PLANNING AND DEVELOPMENT SERVICES STAFF REPORT

**SUBJECT: 410 First Site Plan for City Council Approval
(408 and 412 North First Street)
File No. SP14-058**

DATE
4-20-15
3-31-15
11-24-14
SCALE 1"=10'
DR. K.K. CH. K.K.
SHEET NO. SP-03

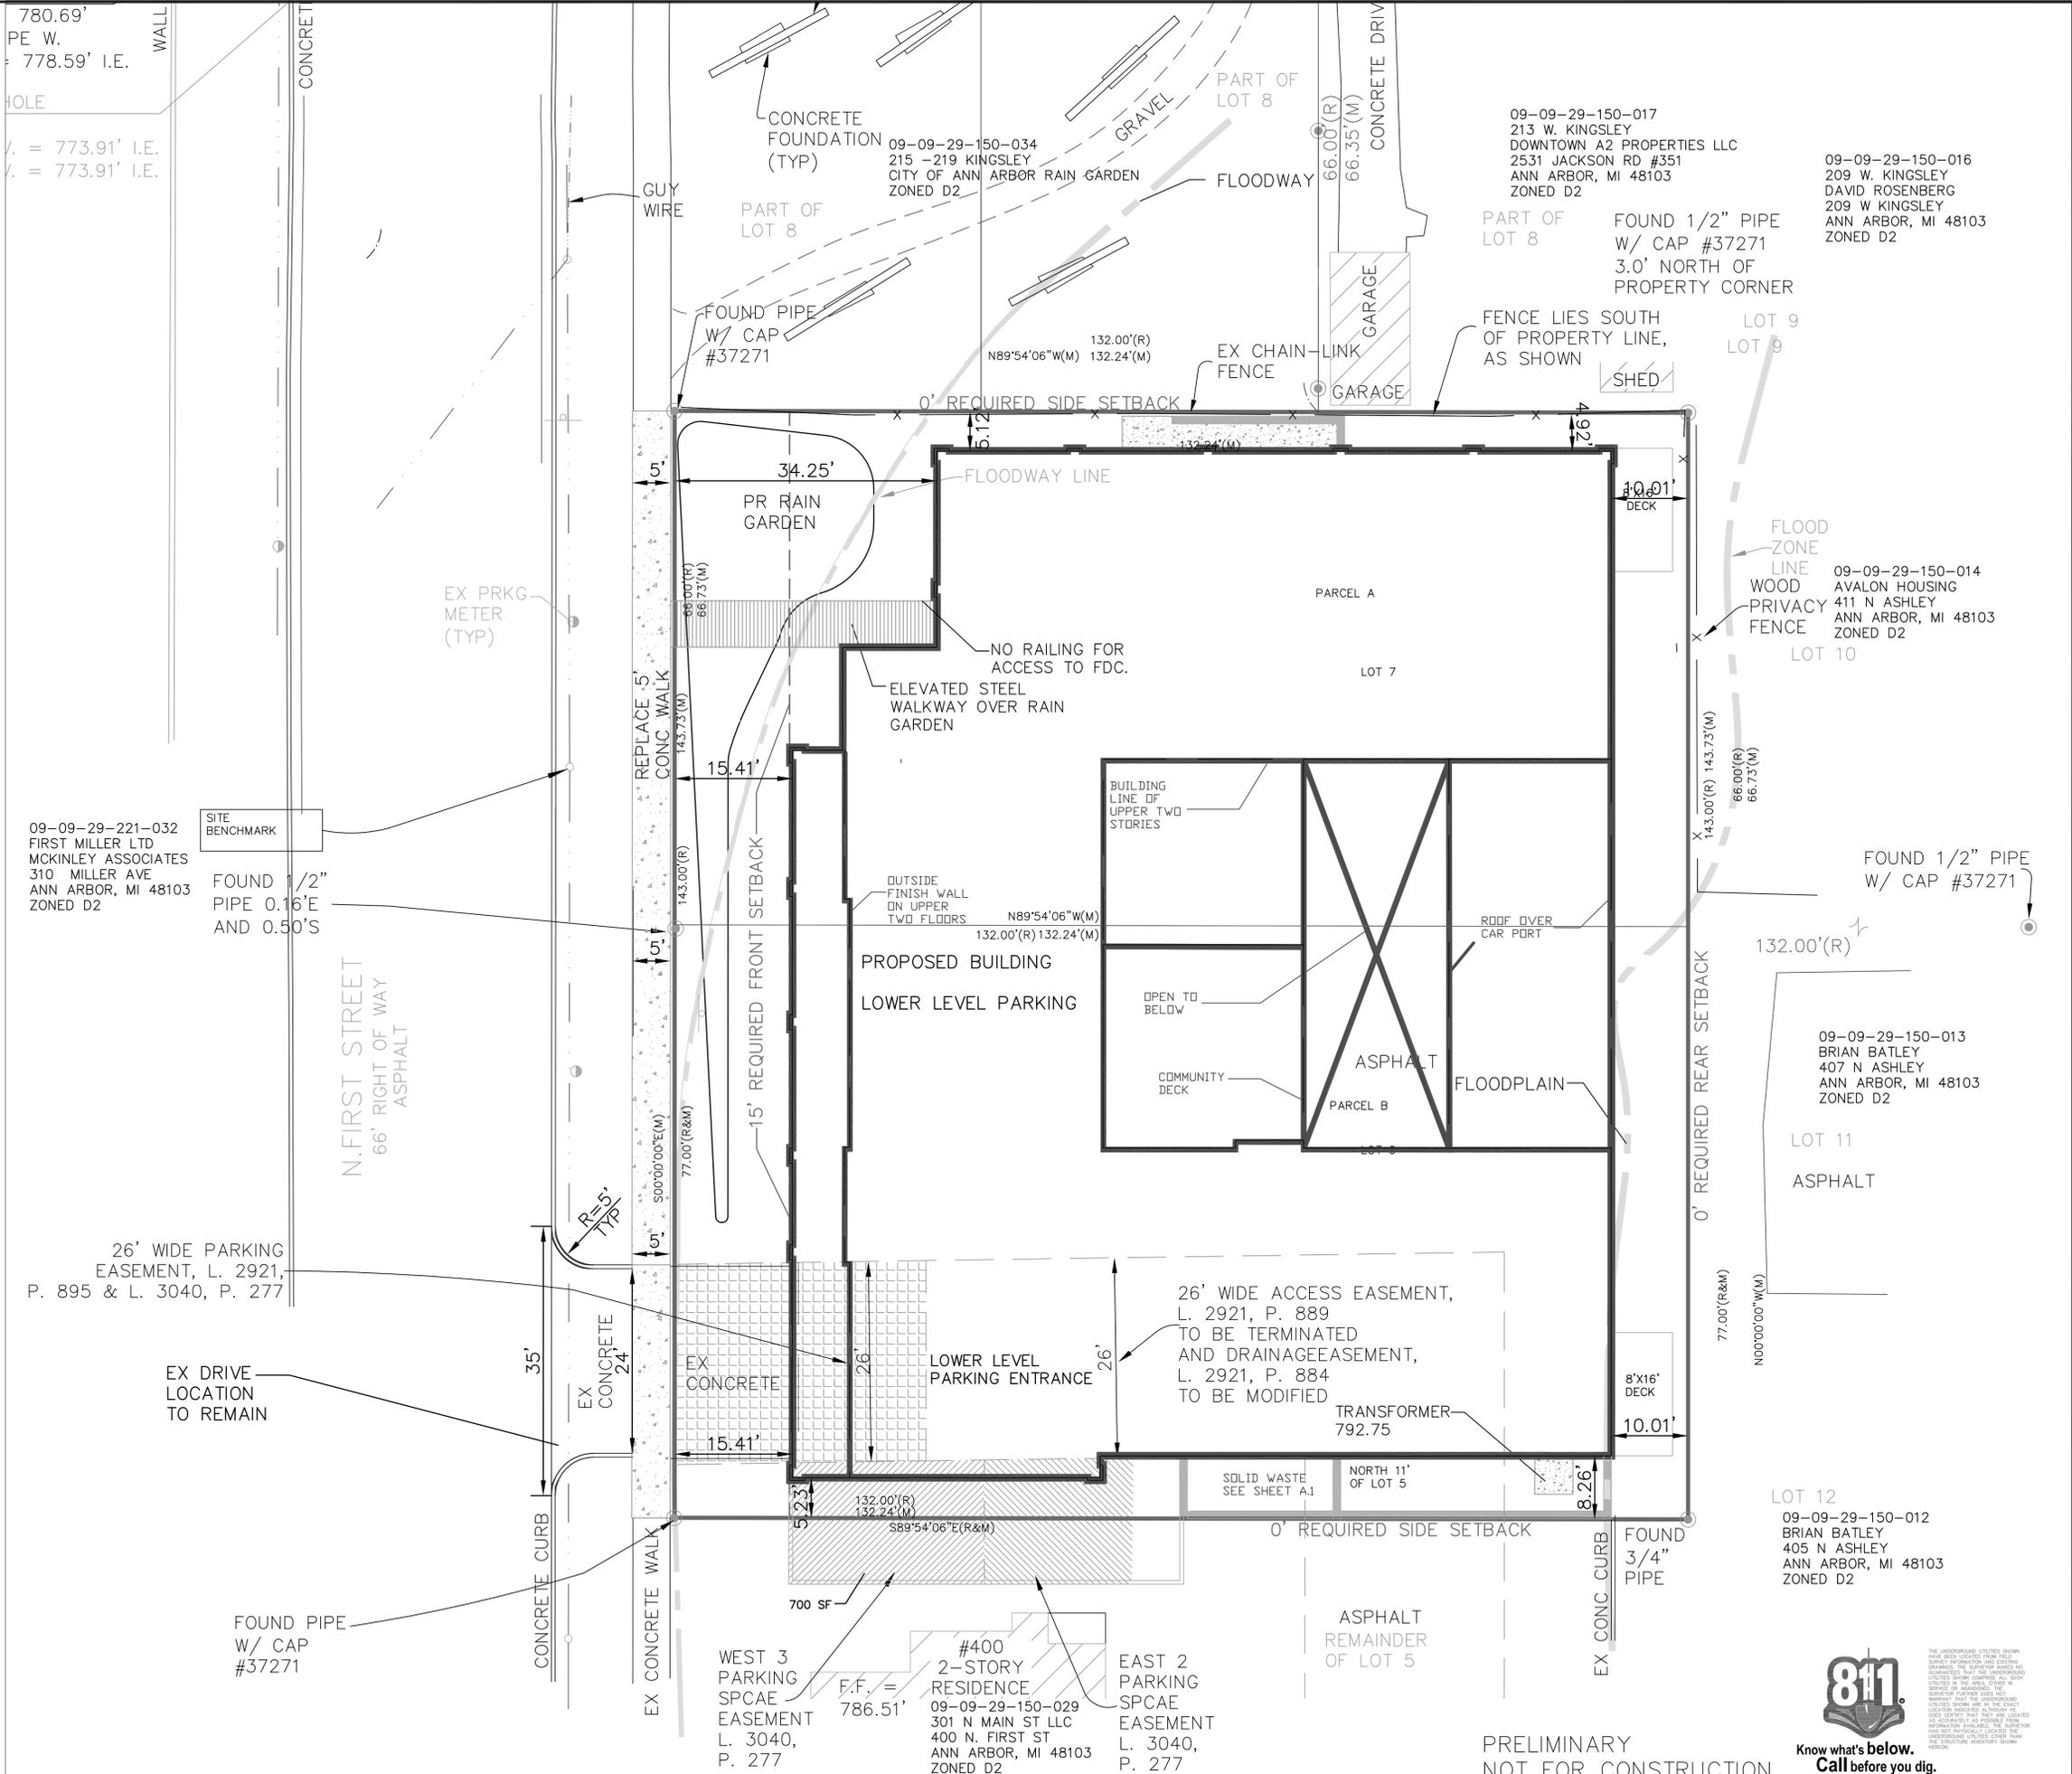
Systems Planning, Floodplain – Per Chapter 57, Section 5:127(1)(c) encroachments into floodplain areas shall be mitigated to provide no net loss of flood storage capacity. The current plan does not provide a summary of the cut and fill information to verify compliance with this requirement, but does appear to have a net gain of flood storage capacity.

4-20-15
12-24-14
DATE 11-24-14
SCALE 1"=10'
DR. K.K. CH. K.K.
P.M.
BOOK
SHEET NO.
SHEET NO.
SP-05

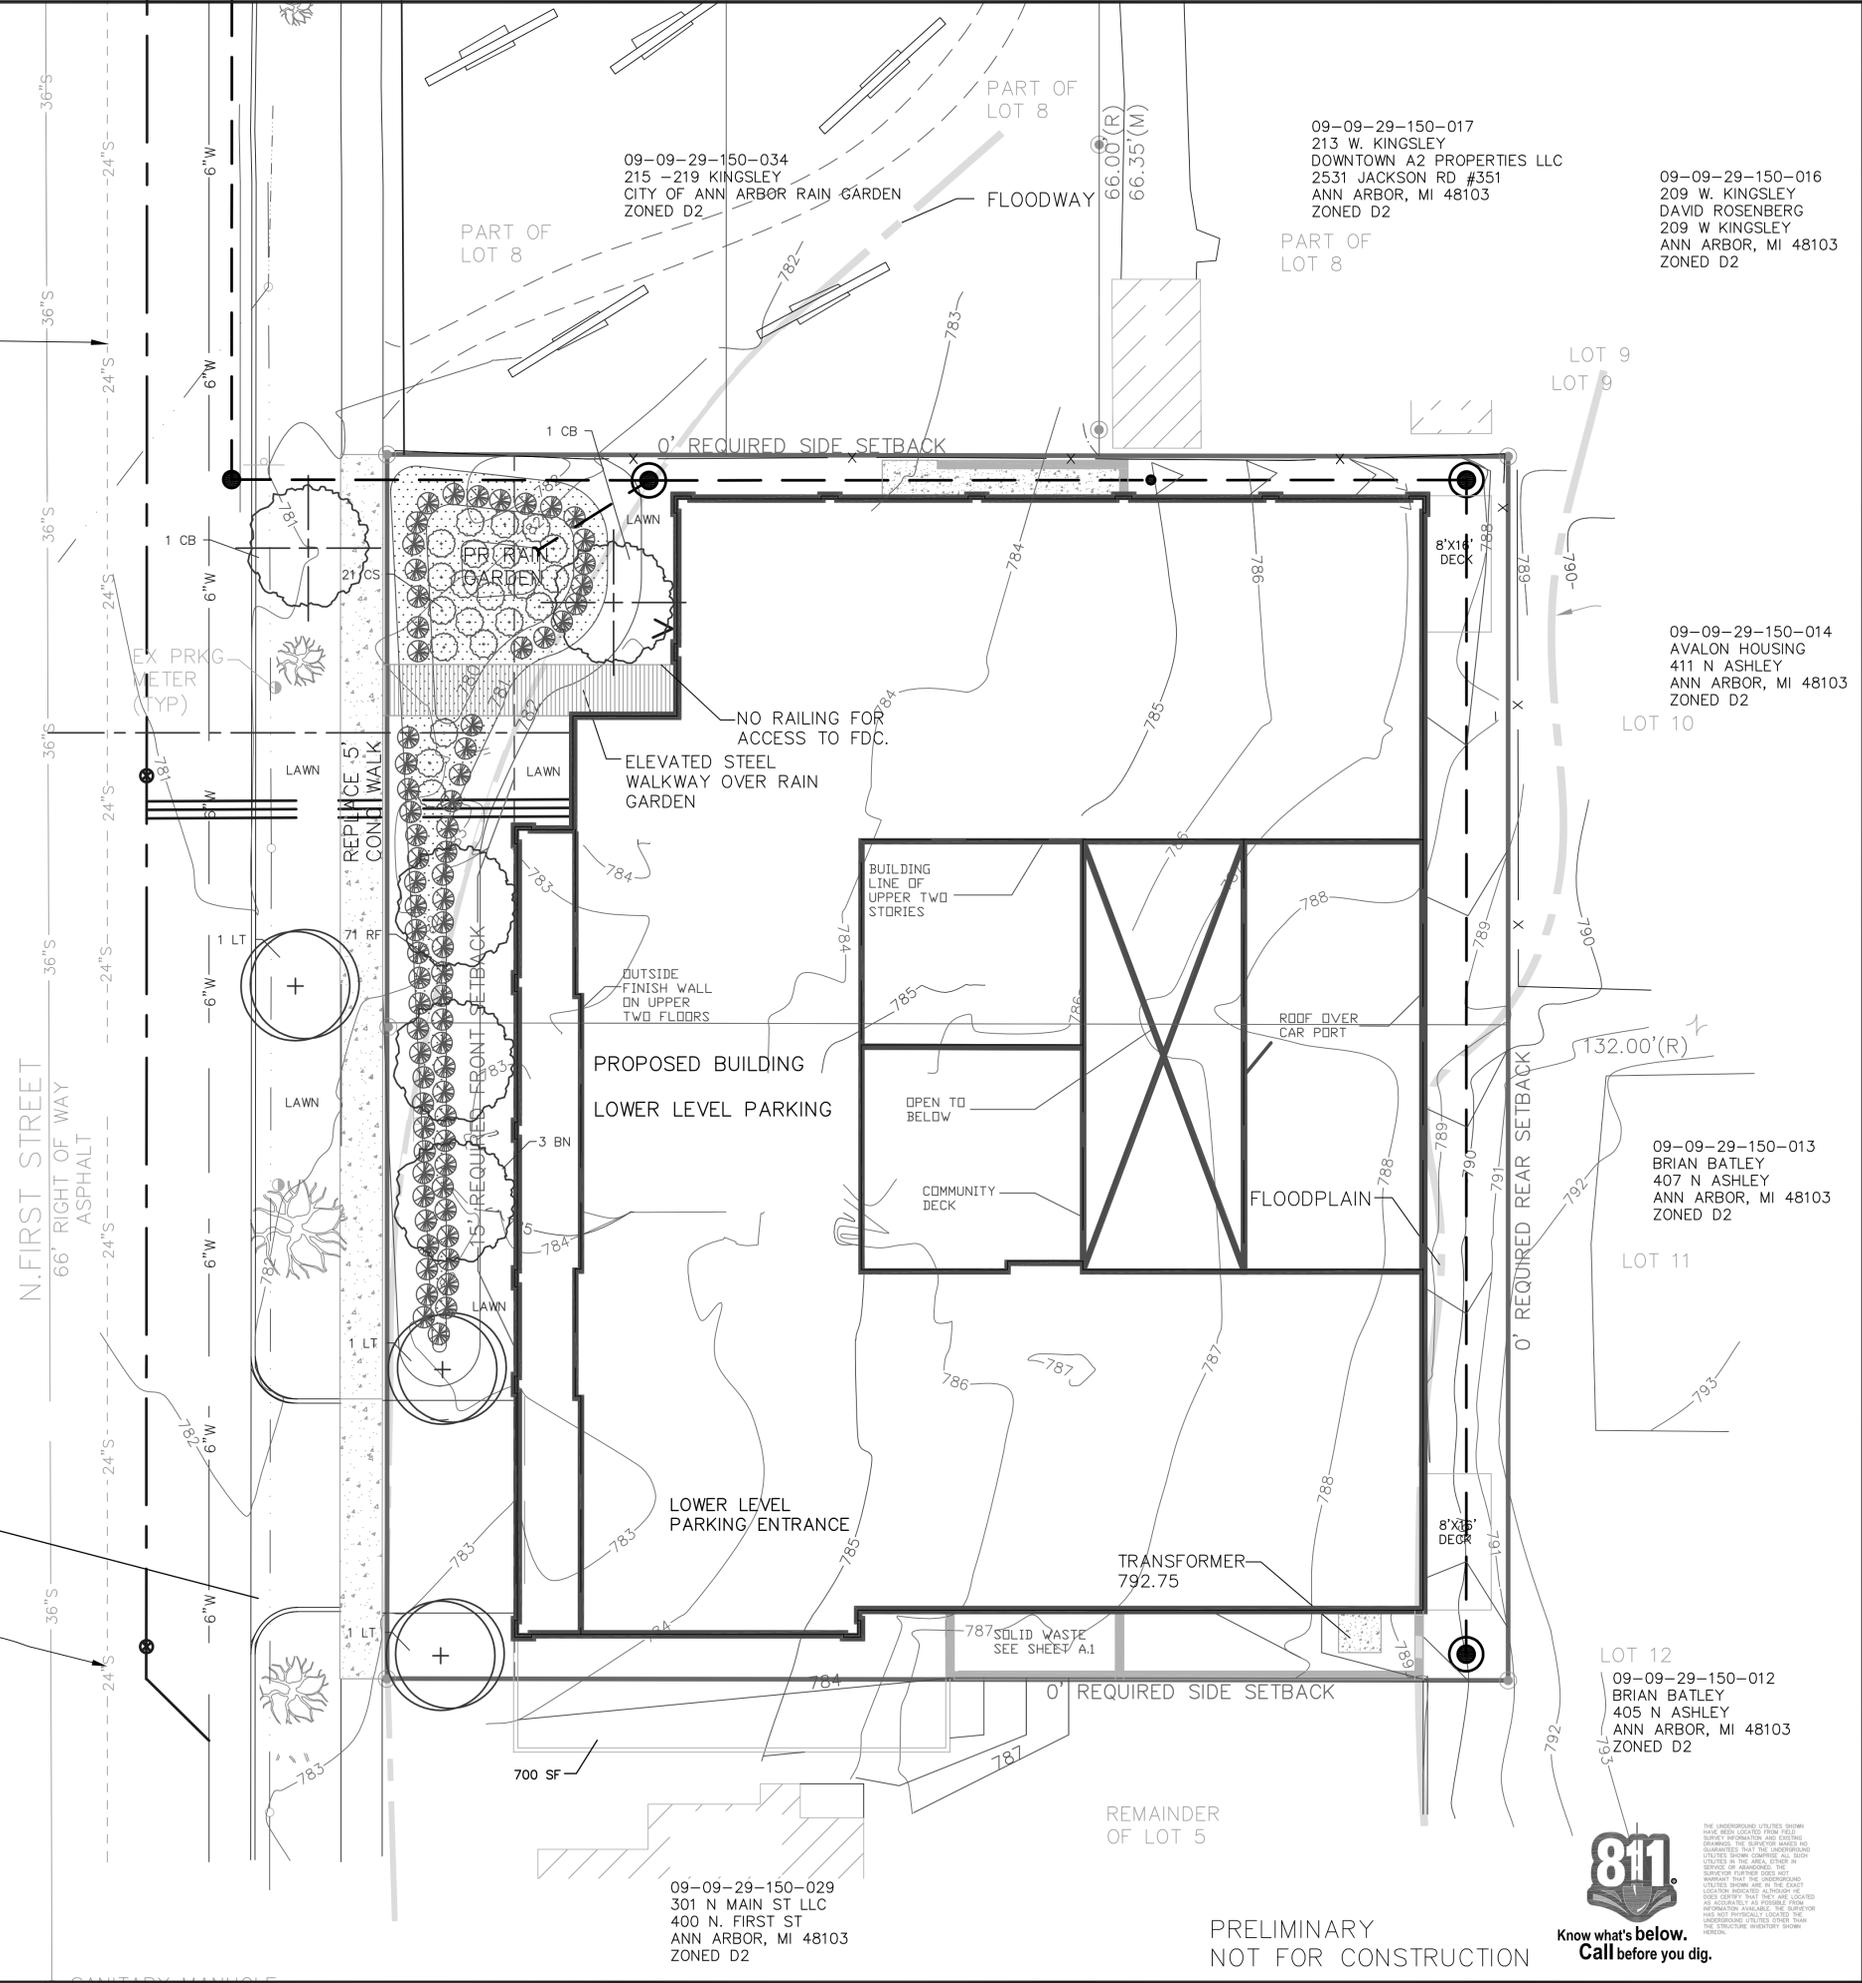
1. *This corner of downtown, and this block in particular, appears to be in transition. (A.1.)*
2. *More information, and clarity, on the landscape plan is needed to better determine whether the proposed design enhances the pedestrian experience (A.1.2)*

4. *How solar access is accommodated should be clarified, or should be included (A.2.2)*
5. *Tree species should be appropriate to floodplains (A.2.5)*
6. *The front yard rain garden and bridge to the main entrance are unique and attractive elements contributing to the streetscape of the block.*
